**Re: Hudson Conservation Commission List of Additional Items 7/27/20 – Applicants' Response  
Sudbury-Hudson Transmission Reliability and Mass Central Rail Trail Project**

# SUDBURY-HUDSON TRANSMISSION RELIABILITY AND MASS CENTRAL RAIL TRAIL PROJECT

DESIGNER: JCR CHECKED: SHK	<b>APPROXIMATE CUT/FILL LOCATION</b>	SHEET NO. <b>1</b> 1 OF 2
DRAWN: JCR CHECKED: TAL		
CONT. P19-3295-D1A ACC. XXXXXXXx	SCALE: NTS DATE: JULY 2020

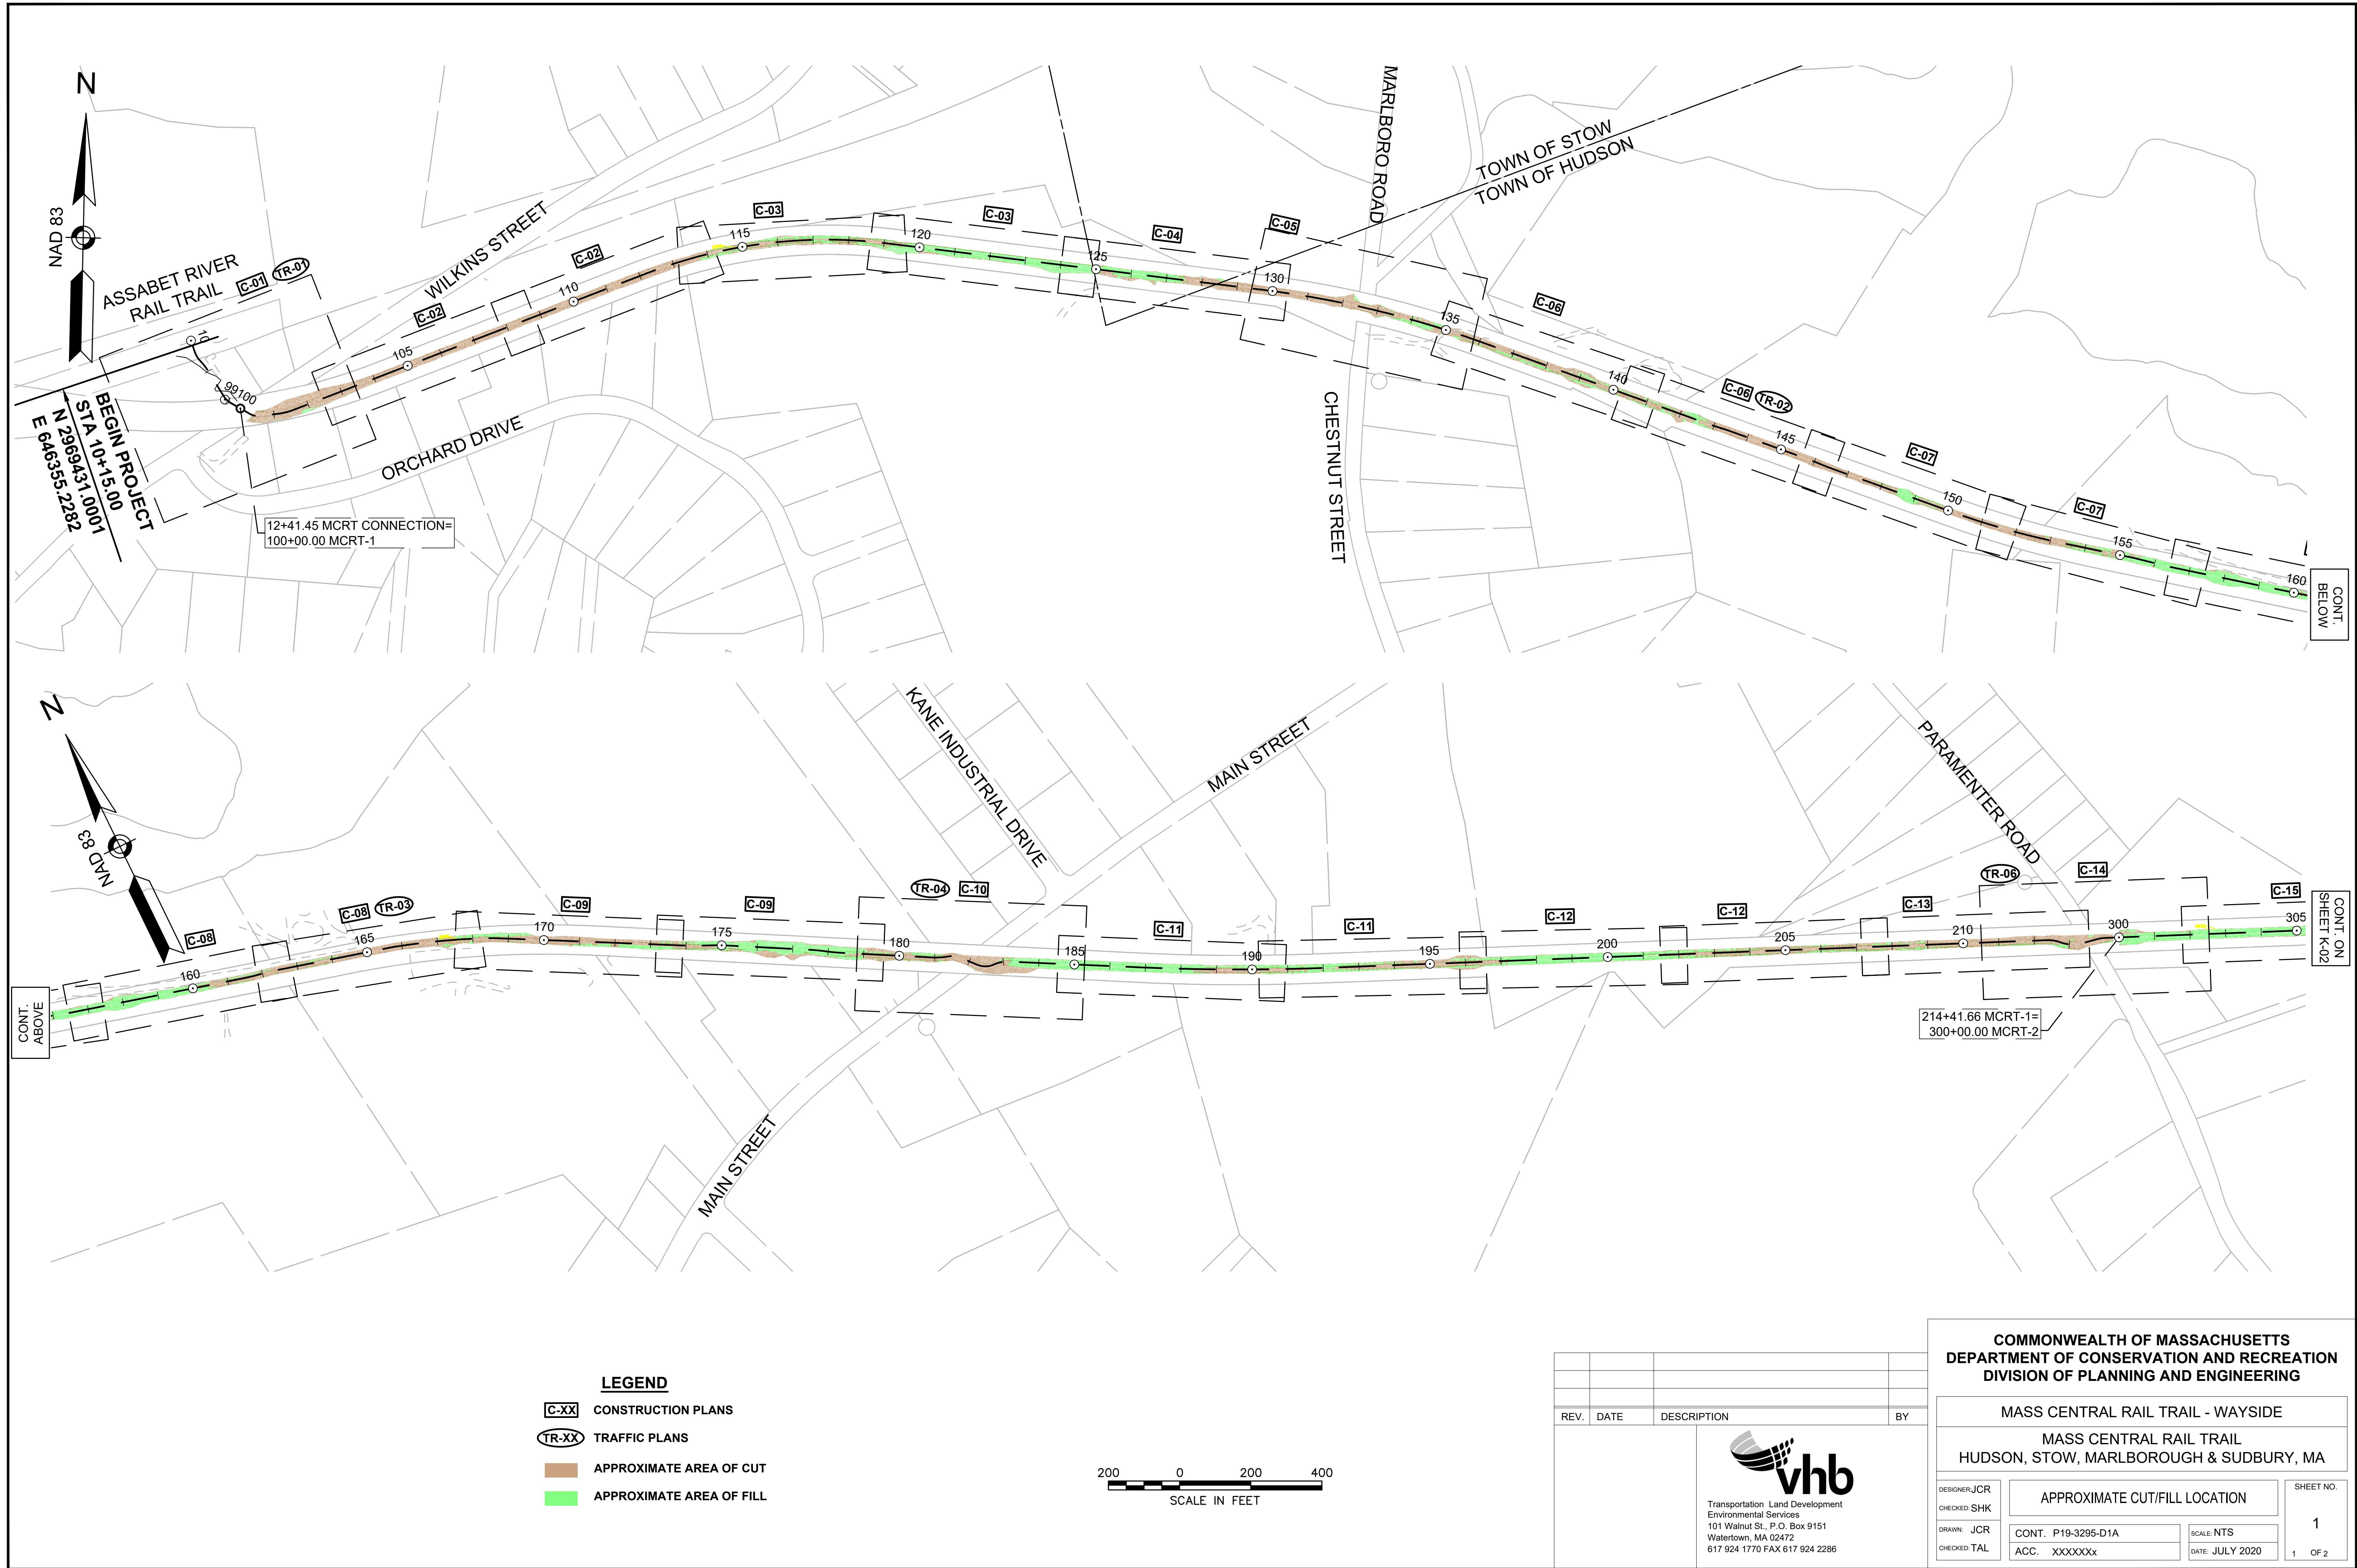
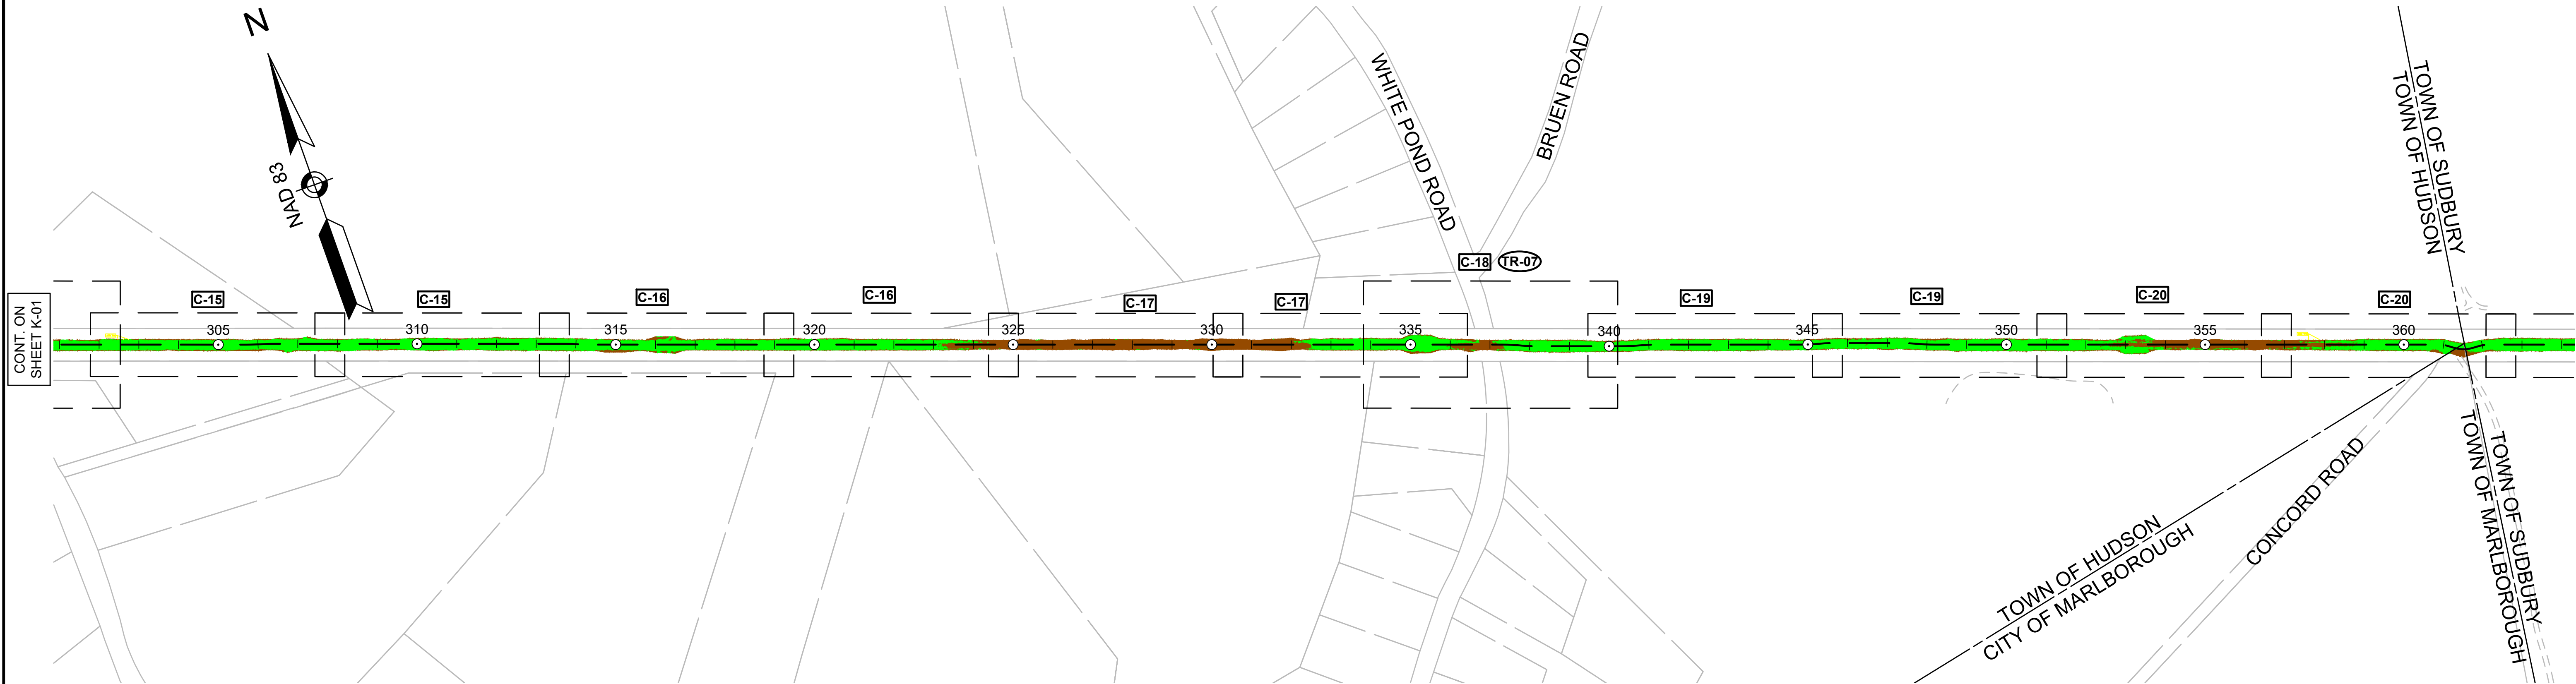
#### **9. Detailed plan for soil relocations**

Approximately 4,994 cubic yards of soil will be reused within the limits of the Project in Hudson, and approximately 13,327 cubic yards of excess soil will be exported from the Project Site in Hudson for

off-site management. The attached figures illustrate cut and fill locations along the Project Site alignment in Hudson.
